WISCONSIN PUBLIC SERVICE CORPORATION

Docket 50-305
Operating License DPR-43
Kewaunee Nuclear Power Plant
Update to IE Bulletin 85-03 Response

Attachment I

KNPP Safety Injection System
(Rev. 1)

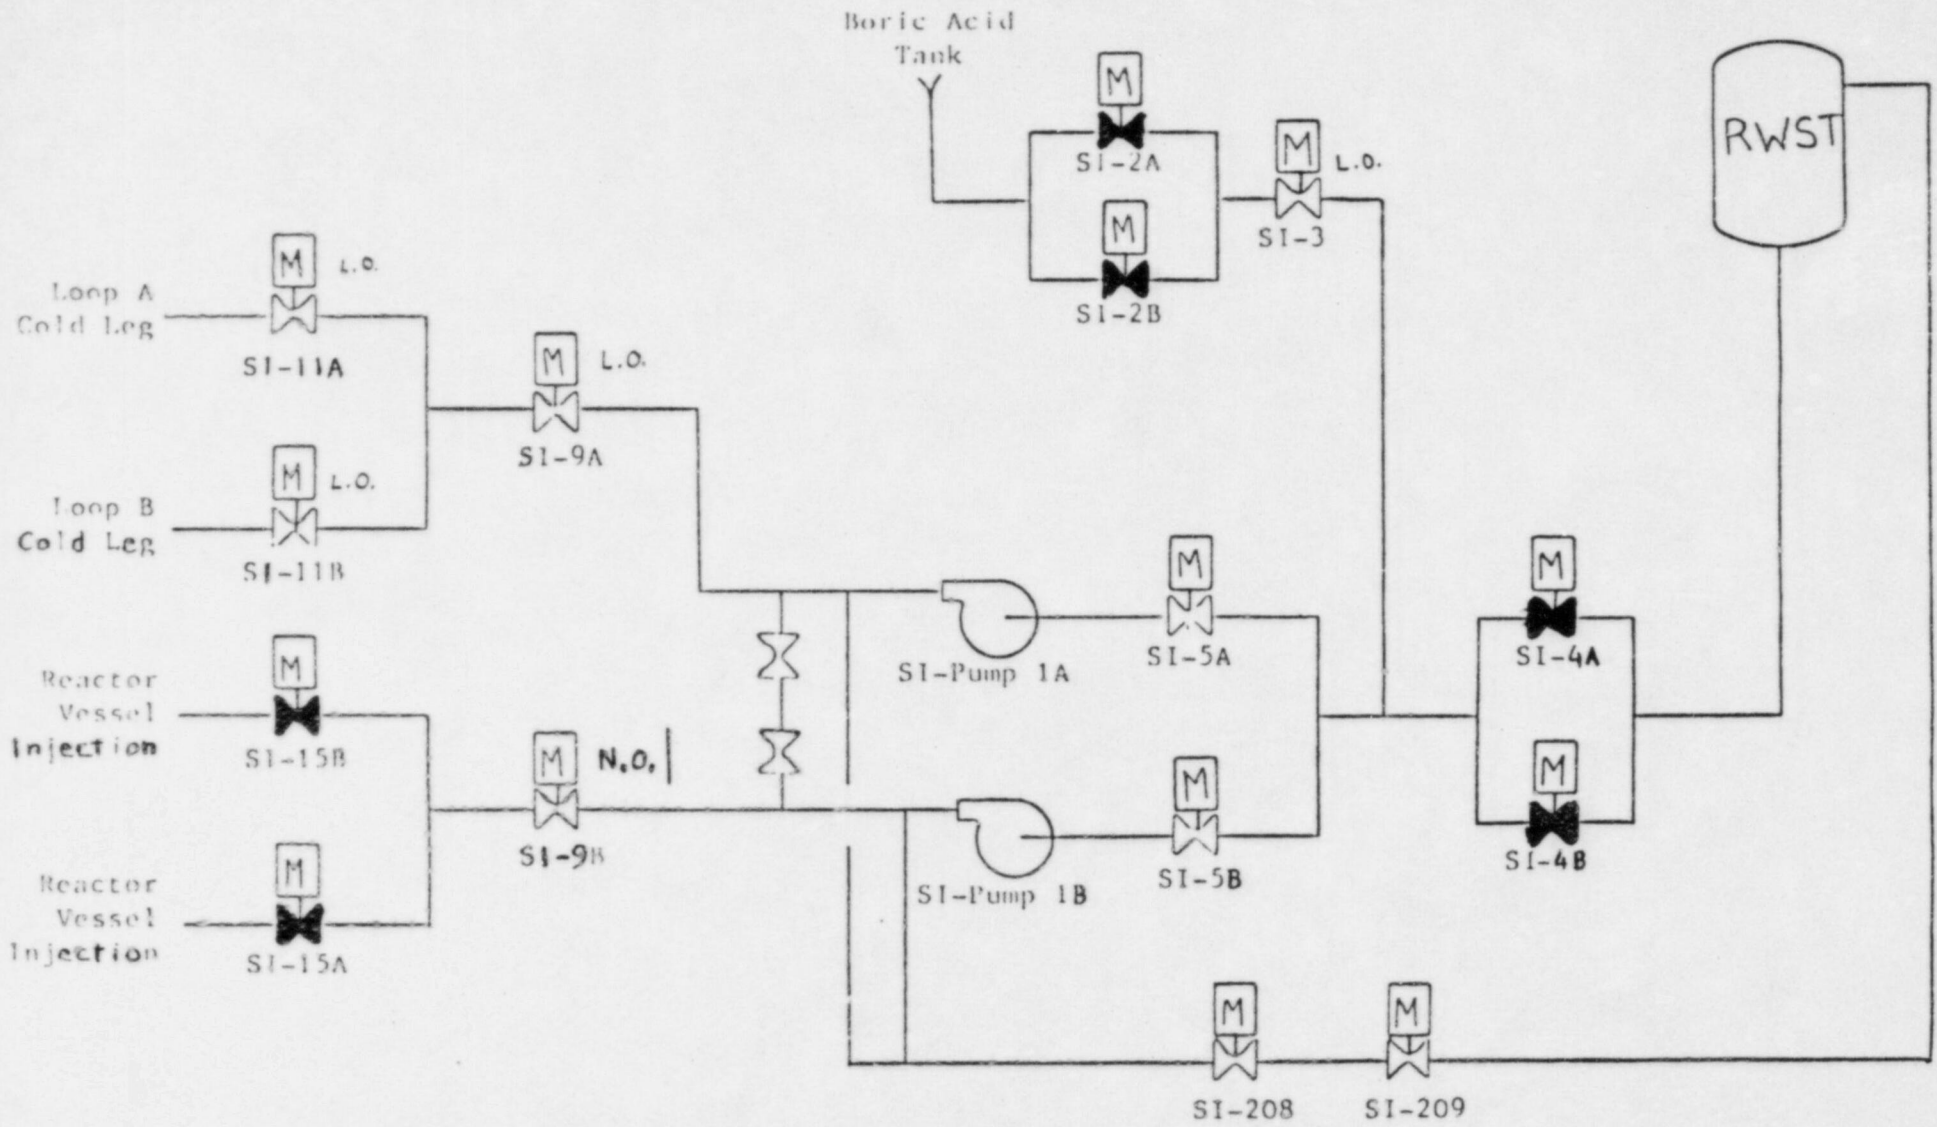
Attachment I to this submittal contains a revised simplified drawing of KNPP's High Head Safety Injection System and should be used in place of the drawing contained in Reference 2. The valve SI-9B is a normally open valve but was inadvertently shown as locked open. This valve is not included in the scope of IEB 85-03. This submittal was delayed as agreed to by Mr. Greenman of NRC Region III staff. The extension was requested in order to allow my staff to perform a more comprehensive review.
